WEST SUSSEX COUNTY COUNCIL CONSULTATION

TO:	Arun District Council - FAO:Anita Gardner
FROM:	WSCC - Highways Authority
DATE:	12 January 2022
LOCATION:	Land rear of Paynters Croft Burndell Road Arundel BN18 0HR
SUBJECT:	F/22/21/PL 23 No dwellings with associated access, infrastructure, landscape and open space (resubmission following F/5/21/PL). This application is a Departure from the Development Plan & is in CIL Zone 3 and is CIL Liable as new dwellings. More information received.
RECOMMENDATION:	No Objection

LAND AT BURDELL ROAD, YAPTON, WEST SUSSEX RESIDENTIAL DEVELOPMENT

Road Safety Audit Stage 1

Figure 2.1: Summary Speed Survey Data

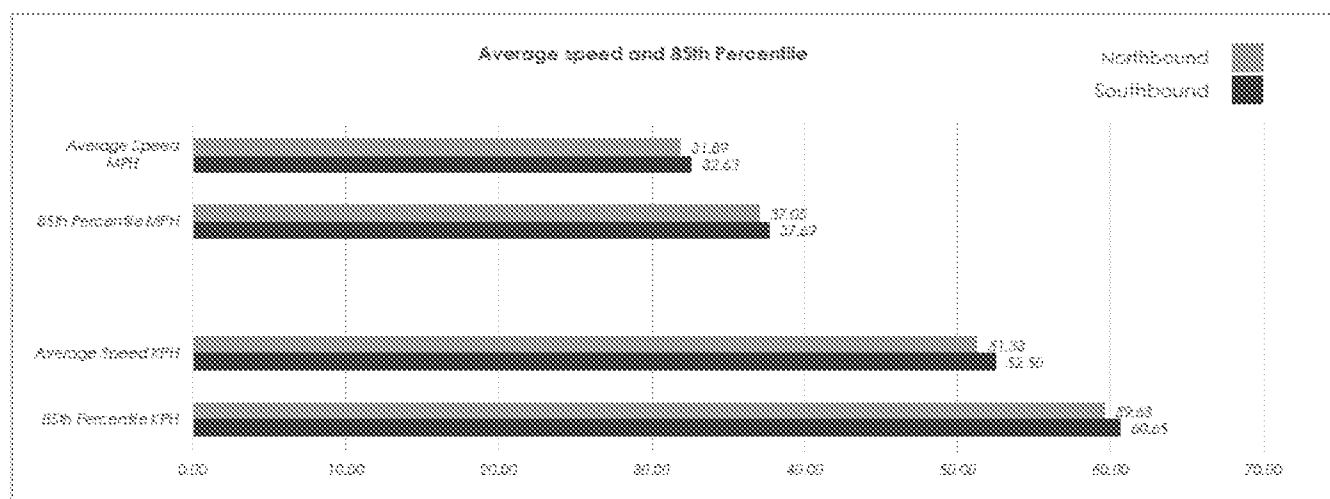
"ATC surveys taken during lockdown periods are acceptable for use in calculating 85th percentile speeds and concurrent visibility splay requirements but should not be used for traffic volume counts. The TS has taken a different approach where splays concurrent to the speed limit of 30mph and to a maximum design speed of 60kph (37.3mph) have been demonstrated. As speeds could be varying and above 37.3mph a 7-day speed survey is required to ascertain the up to date 85th percentile speeds in either direction, in vicinity of the access, along with amended vehicle visibility and pedestrian forward visibility splays in accordance with these recorded speeds."

- 2.2.1 An ATC speed Survey was undertaken between the 11th and 17th of July 2021 to establish design speeds on Burndell Road. The ATC data has been filtered in accordance DMRB CA 185 requirements. A summary of the speed data is provided in **Figure 2.1**.

- 2.2.2 The southbound design speed narrowly exceeds 60kph, a threshold at which DMRB CD 109 visibility requirements need to be considered. DMRB CD 109 identifies relaxations to the 'desirable minimum' stopping sight distance are permitted on Band B 60kph urban trunk roads. The low proportion of HGV's (<1%) on Burndell Road further supports relaxation from the desirable minimum as detailed in MfS 2 Section 10.1.

- 2.2.3 The secondary direction visibility splay has therefore been shown in accordance with DMRB 'absolute minimum' requirements equating to a stopping sight distance of 72.0m. The primary direction visibility splay has also been provided in accordance with DMRB absolute minimum requirements for consistency (although speeds on this approach direction fall below the DMRB 60kph threshold) equating to a stopping sight distance of 70.0m. The revised primary and secondary visibility splays are demonstrated in **Drawing 2020-6145-001**.

- 001** Access Overview & Visibility Splays
- 002** Cycle Route Overview

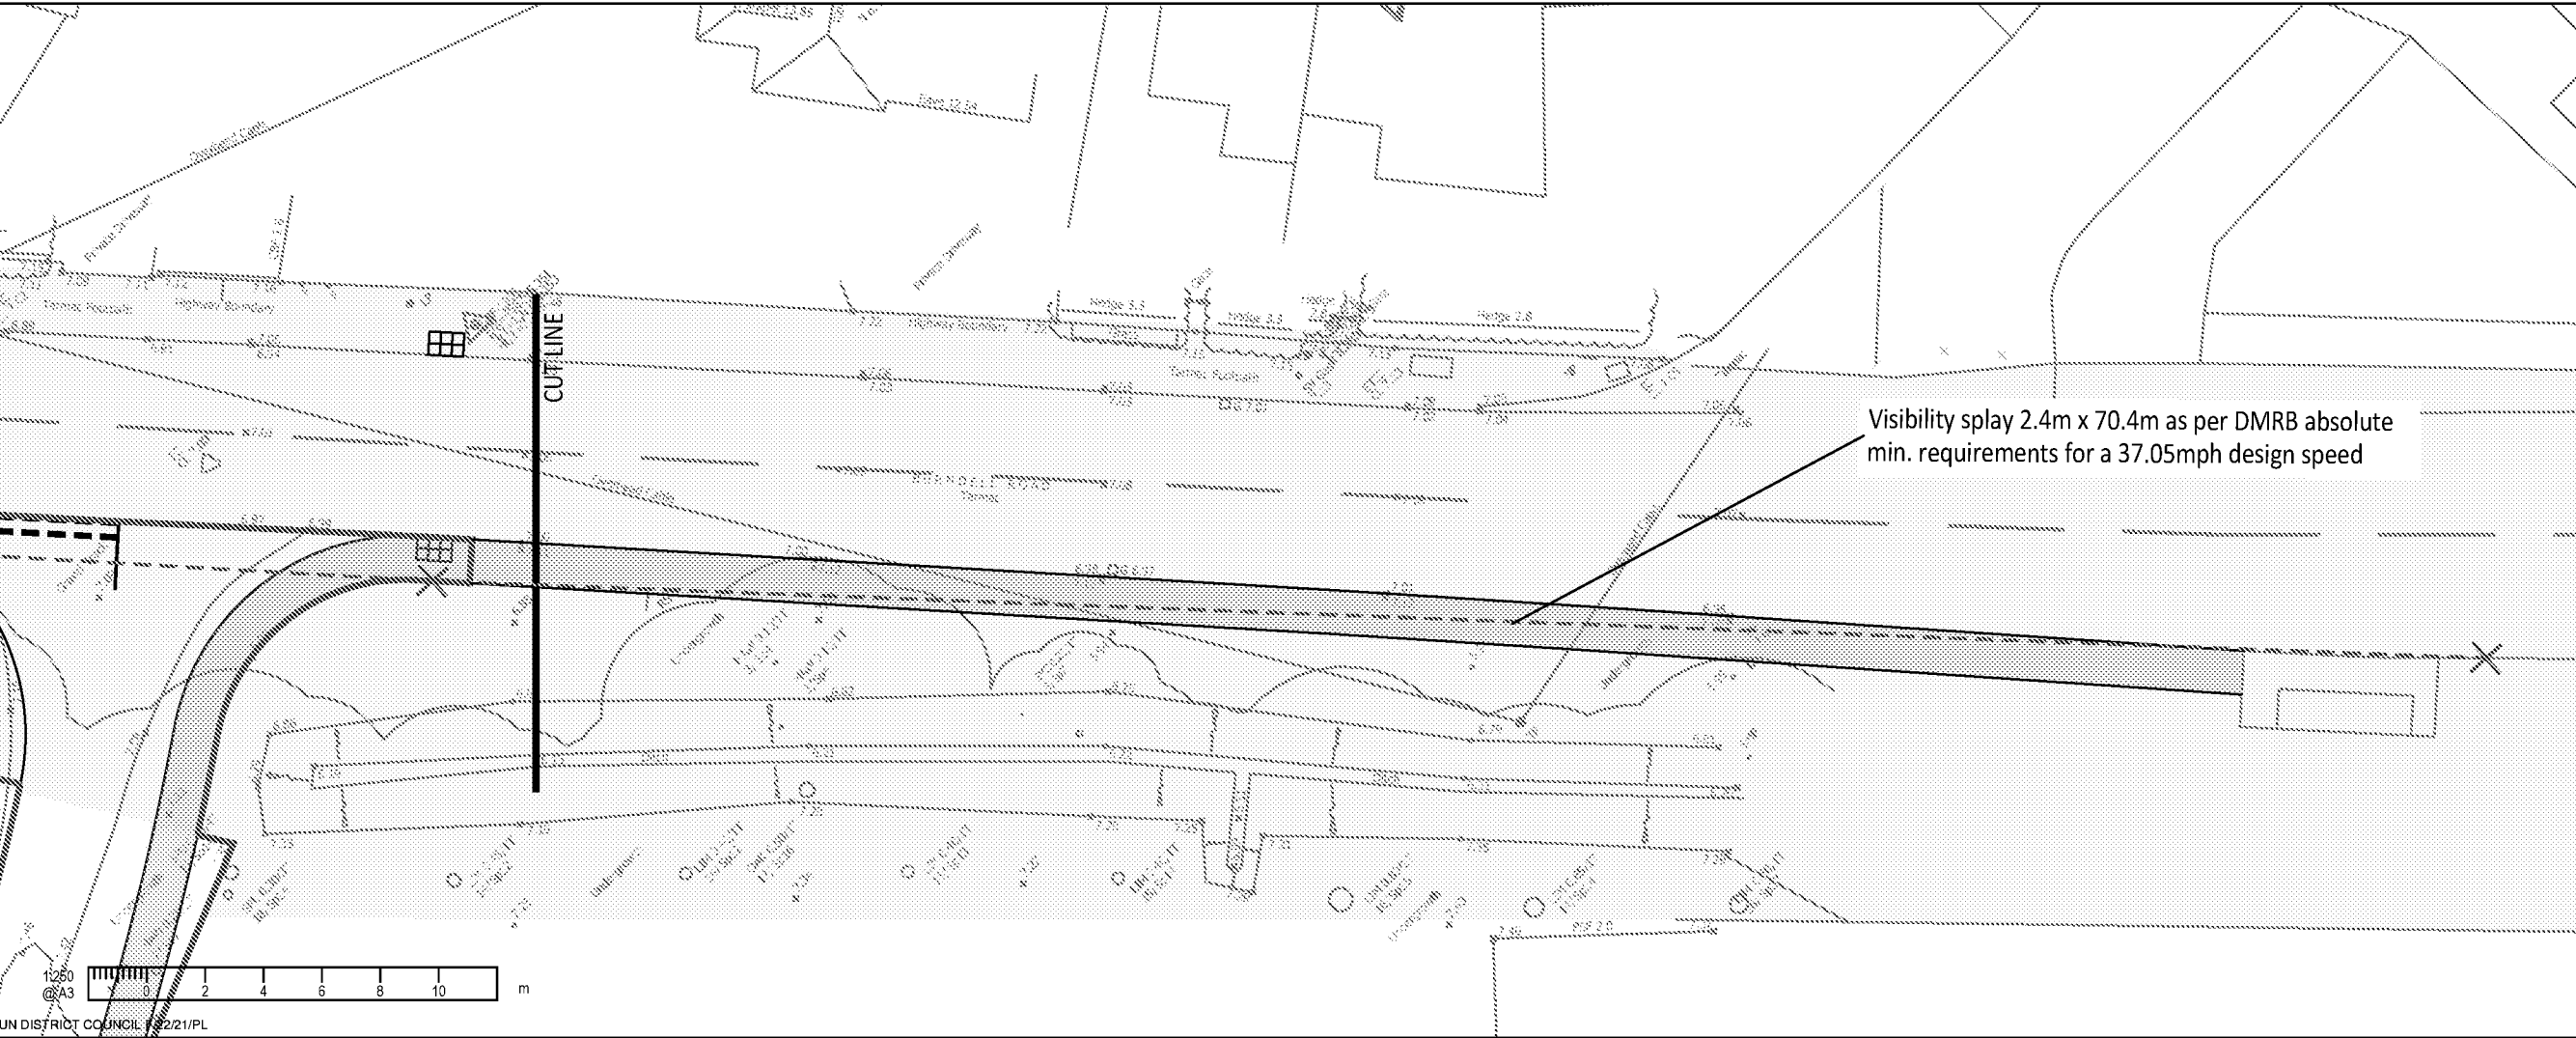
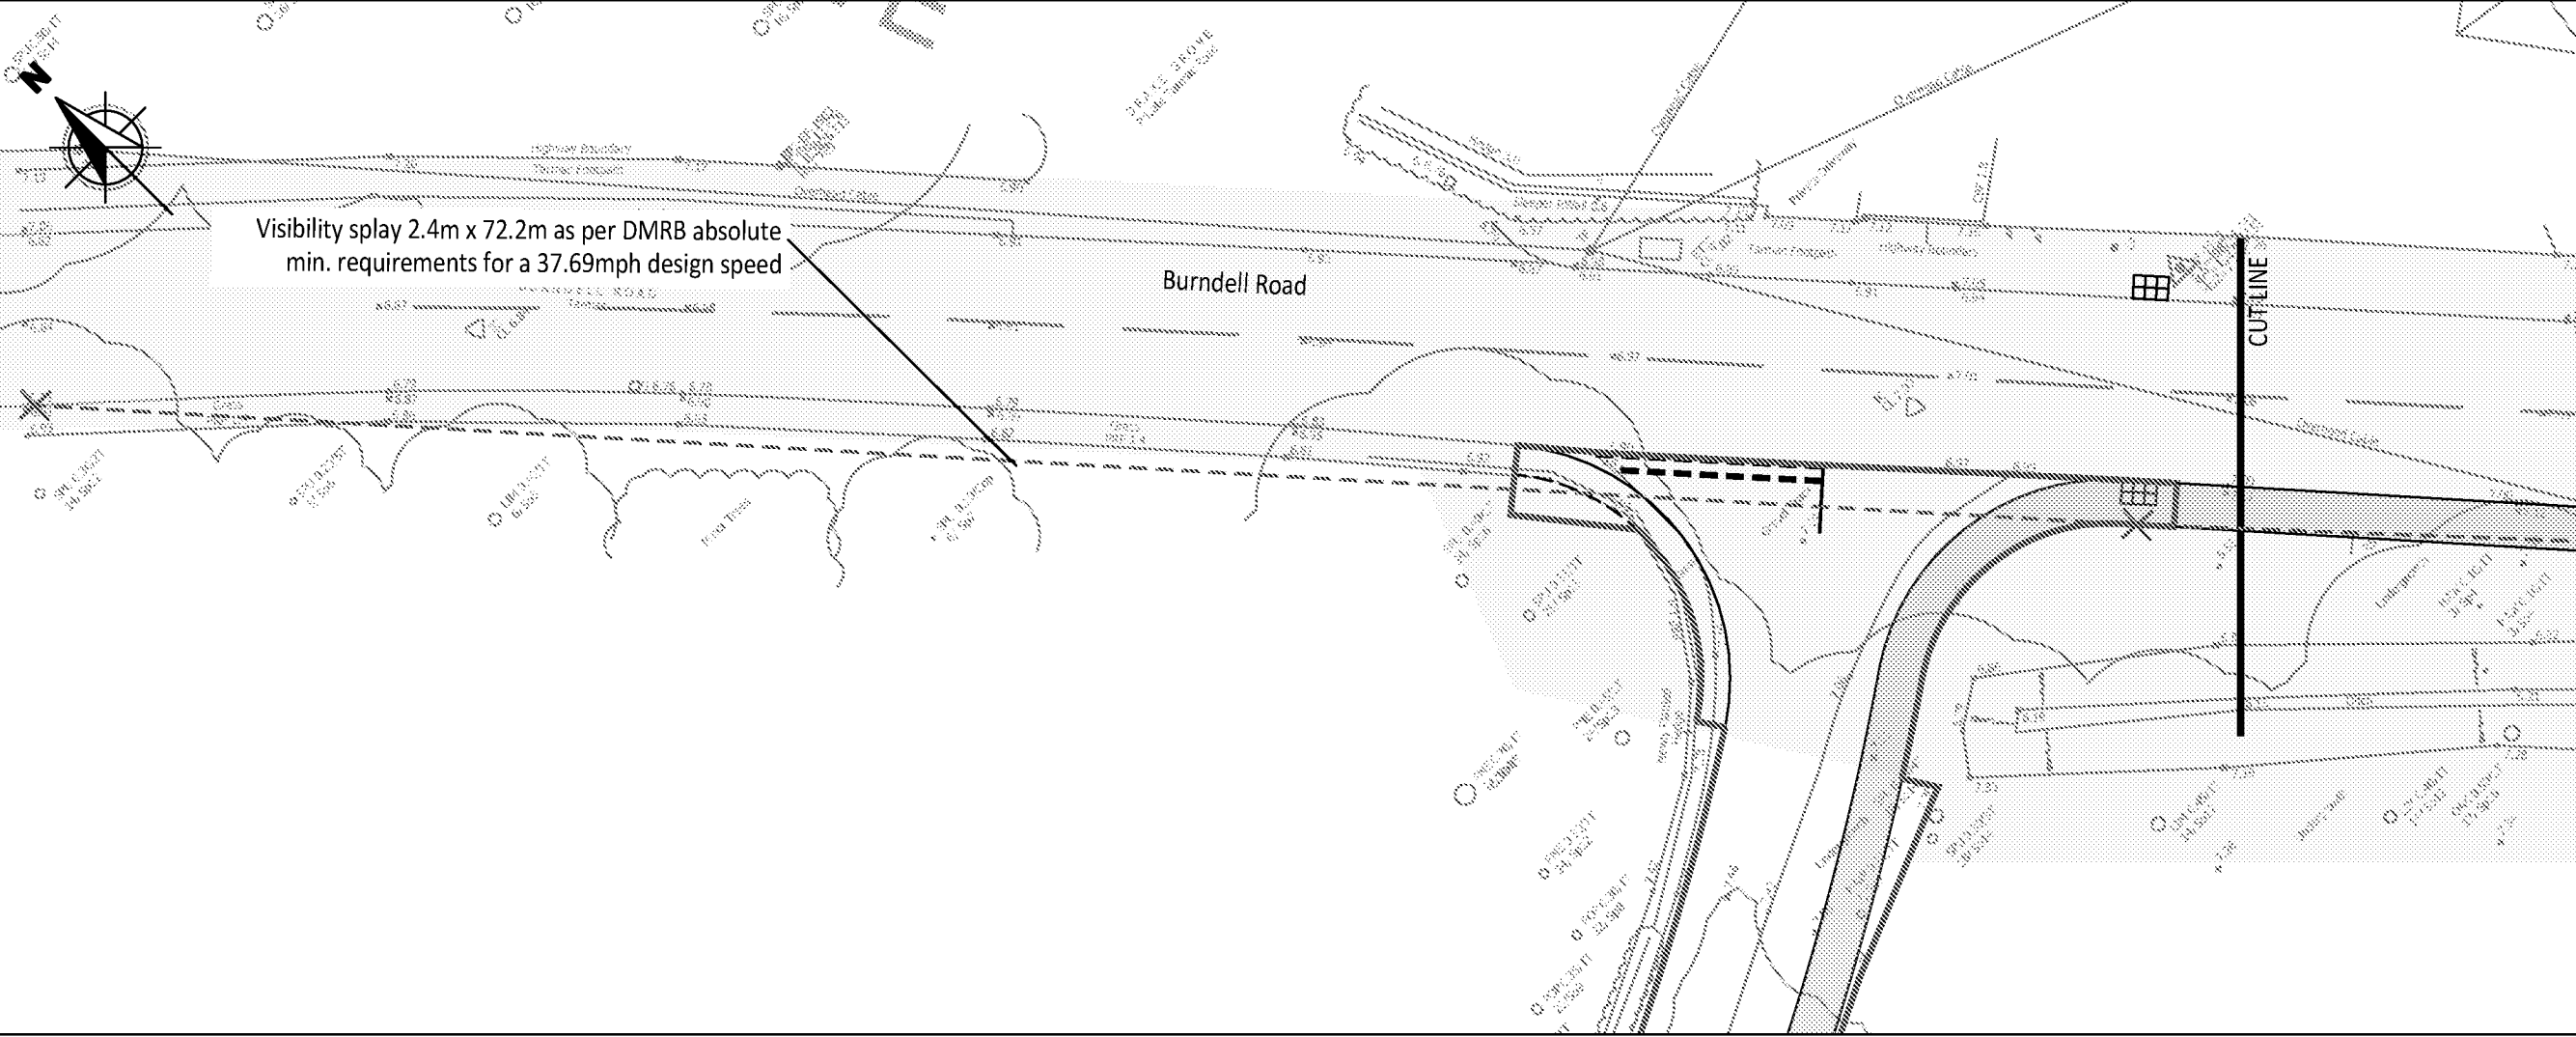
- Show splays of 2.4m by 58m south and 60m north can be accommodated without passing through third party land.
- Clearly show extent of footway from access road past plots 1 and 2.
- Ensure single garages of 3m width.

"A Stage 1 Road Safety Audit (RSA) with accompanying Designers Response (in the format as set out in table F4 and F5 of GG119) should be provided to cover all proposed highways/ access works and modifications."

Drawing no. 2020-6145-001 Rev J (Access Overview and Visibility Splays) shows 2.4m by 58m south (entirely within adopted highway land) and 2.4m by 60m north within adopted highway land and red edge of site. The Local Planning Authority (LPA) should be satisfied that red edge shown is land within applicants control, in order to maintain the splays in perpetuity.

Drawing no. 2020-6145-002 Rev I (Proposed Access Road Overview and Dimensions) shows the correct access road footway arrangement and the Site Overview plan confirms that the footway will continue past plot 1 and 2 within the site.

Photo 3: Looking north-west at the bus stop and existing access to the development site (at the post and rail fence)

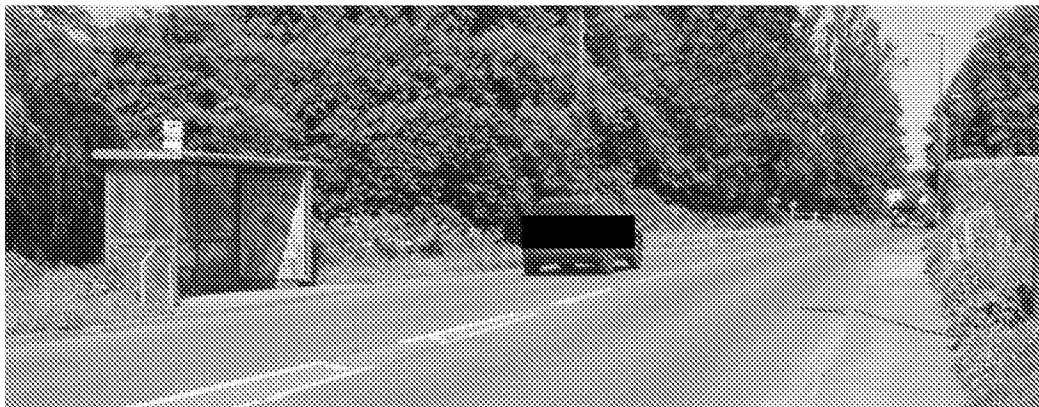
The pedestrian visibility splays drawing shows that, 60m away from the proposed uncontrolled pedestrian crossing point on Burndell Road, there is a bus stop and shelter for north-westbound buses (photo 3).

Residents of, or visitors to, the new development, wishing to use the north-westbound bus route, will have to cross Burndell Road twice to do so, once using the new uncontrolled crossing at the new access junction, and again at the existing bus stop, where there are no dropped kerbs or tactile paving (photo 4).

It is more likely, however, that pedestrians will walk along the verge between the bus stop and the new development, risking trips and falls on the verge, or will walk in the carriageway when the verge is muddy, risking collisions with passing traffic.

The footway on the south-east shoulder of the development should be extended 60m to the existing north-westbound bus stop. This will also help safeguard the visibility splay south-eastwards from the development access junction (see problem 2.1 above).

Problem no.	Problem Accepted (yes/no)	Recommended Measure Accepted (yes/no)	Design Organisation Response	Over Seeing Organisation Response	Agreed RSA Action
2.1	Yes	Yes	All vegetation will be removed from within the visibility envelope. Vegetation to be replaced with grass to the north west and a 1.5m wide footway to the south east.	agreed	
2.2	Yes	Yes	The footway has been extended c.60m to the southeast to provide access to the existing bus stop.	agreed - noted improvement

Problems Location Plan

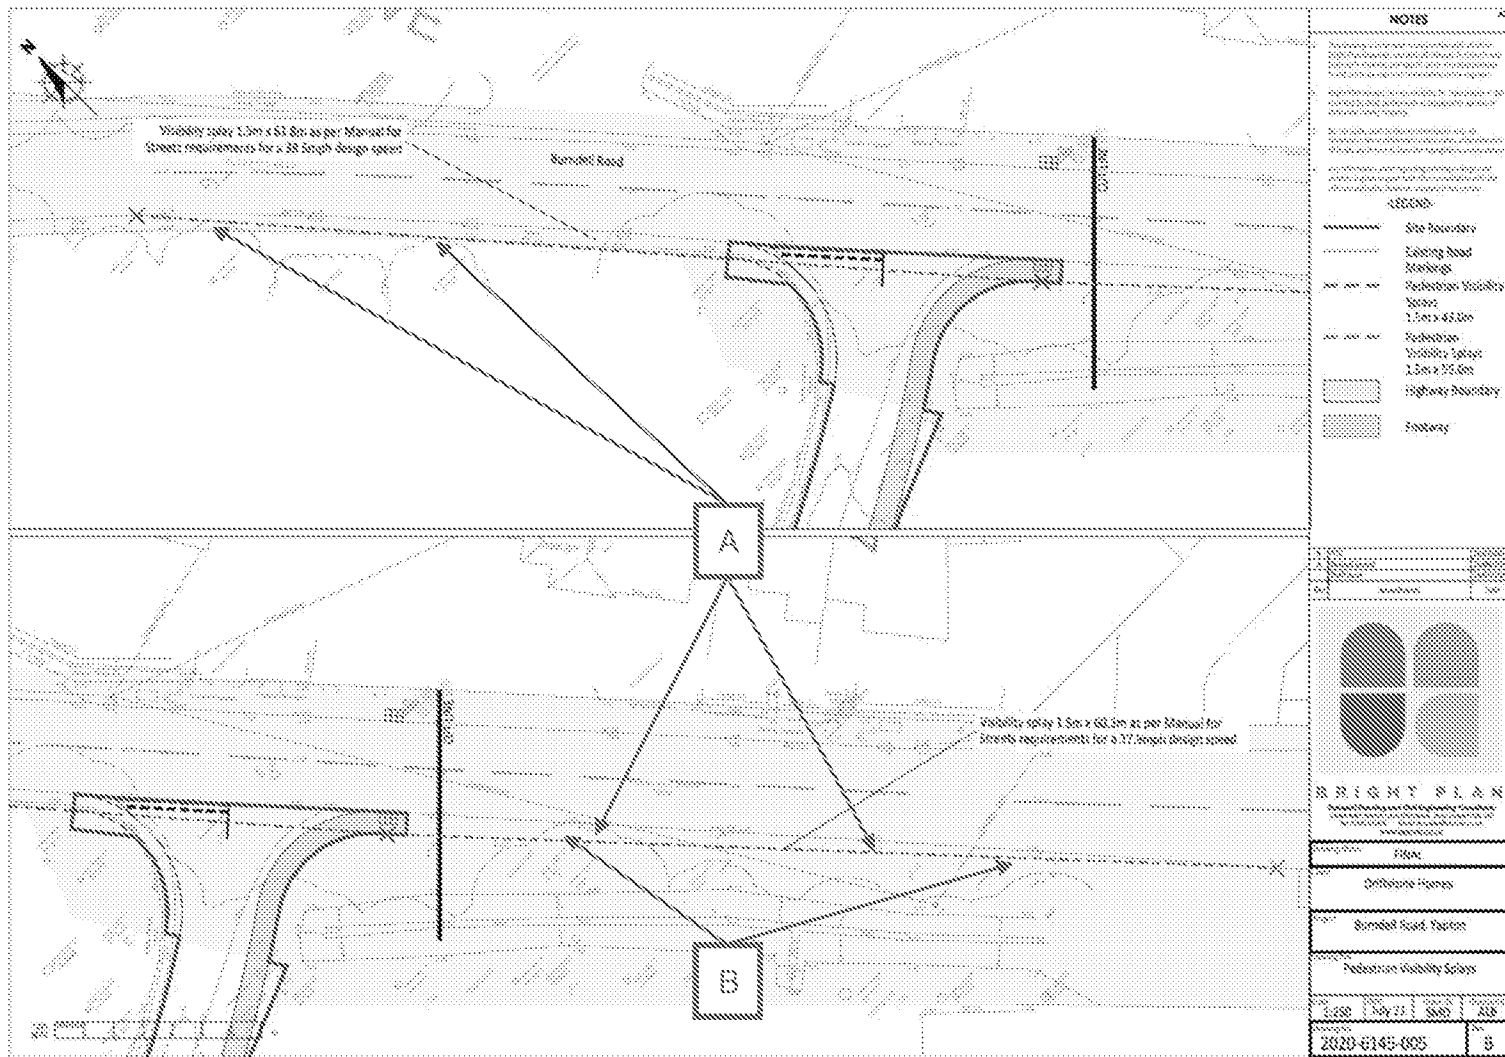
Locations: A – The access junction onto Burndell Road (Dwg. 2020-6145-001 Rev. H)

Summary: Risk of side impact collisions due to the visibility from the access road being obstructed by vegetation.

Although the post and rail fence will require removal, and the existing vegetation will be cut back, to obtain the visibility splay in both directions from the access road, the amount of overgrown vegetation present (brambles, nettles, low tree branches etc – see photos 1 and 2) will need constant maintenance to ensure that the visibility splays are not obstructed, especially to the south-eastern side of the access junction where approaching traffic will be closest to the give way lines as vehicles exit the development. Any obstruction to visibility is likely to increase the risk of side impact collisions at the access junction.

All vegetation, including low branches from adjacent trees, should be removed completely from within the proposed visibility splays, and replaced with either grass or a footway (to the south-east – see recommendation to problem 2.2).

Location: B – Burndell Road south-east of the access junction (Dwg. 2020-6145-005 Rev. B)

Summary: Risk of pedestrian trips, falls and collisions with passing traffic.
